DESCRIPTION OF PROPOSED CHANGE NPF-10-16 AND SAFETY ANALYSIS  
AMENDMENT APPLICATION NO. 11 OPERATING LICENSE NPF-10

Description of Proposed Change NPF-10-21 and Safety Analysis  
Amendment Application No. 11 to Operating License NPF-10

DESCRIPTION OF PROPOSED CHANGE NPF-10-23 AND SAFETY ANALYSIS  
AMENDMENT APPLICATION NO. 11 TO OPERATING LICENSE NPF-10

DESCRIPTION OF PROPOSED CHANGE NPF-10-27 AND SAFETY ANALYSIS  
AMENDMENT APPLICATION NO. 11 OPERATING LICENSE NPF-10

Figure 6.2-1  
OFFSITE ORGANIZATION  
SAN ONOFRE NUCLEAR GENERATING STATION - UNIT 2

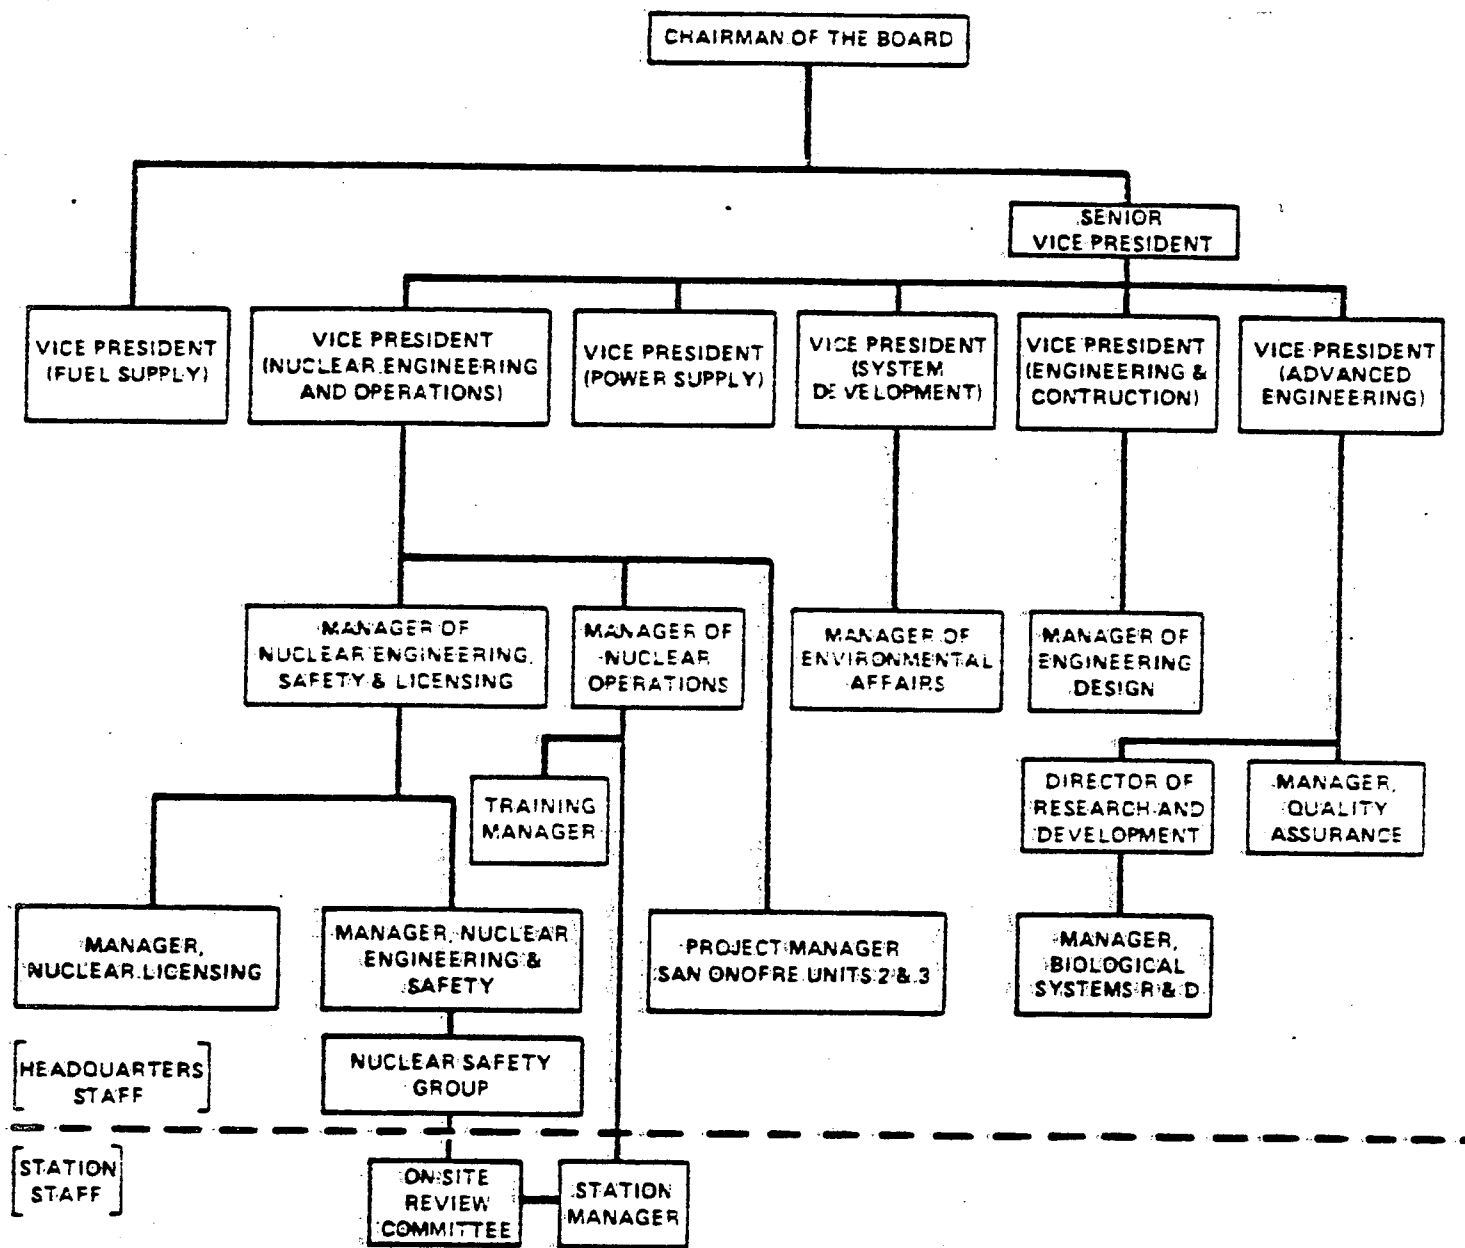
Page  
6-2 Figure 6.2-1, Offsite Organization. The word "Construction" contained in "Vice President (Engineering and Construction" is misspelled as "Contruction."
